Product Change Notification

TE Connectivity

Product Change Notification: P-25-028029

Before Change

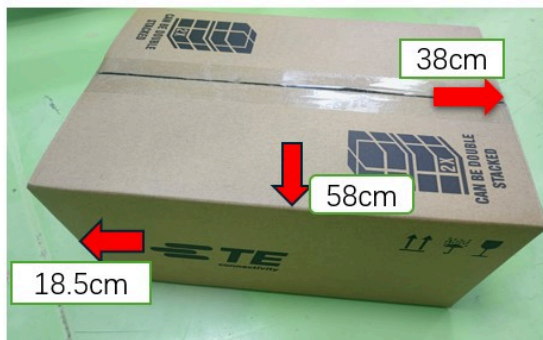
the box is too small to be sealed easily.

The height of box before change: 18.5cm
outer box dimensions: 58cmX38cmX18.5cm.
TE PN of box: 973506-1

Use 973056-1 carton packing, the box is too small to be sealed easily.

After Change

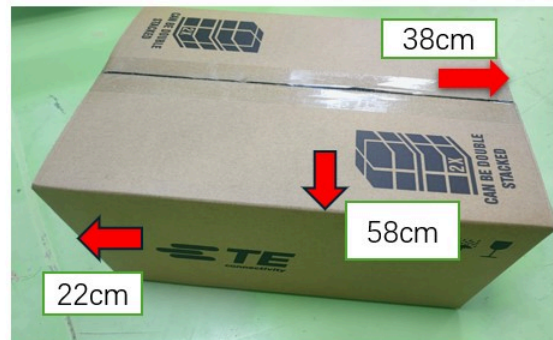
The height of box after change: 22cm
outer box dimensions: 58cmX38cmX22cm.
TE PN of box: 2-1927019-6

Use 2-1927019-6 carton packaging, carton can be sealed flat when packaging
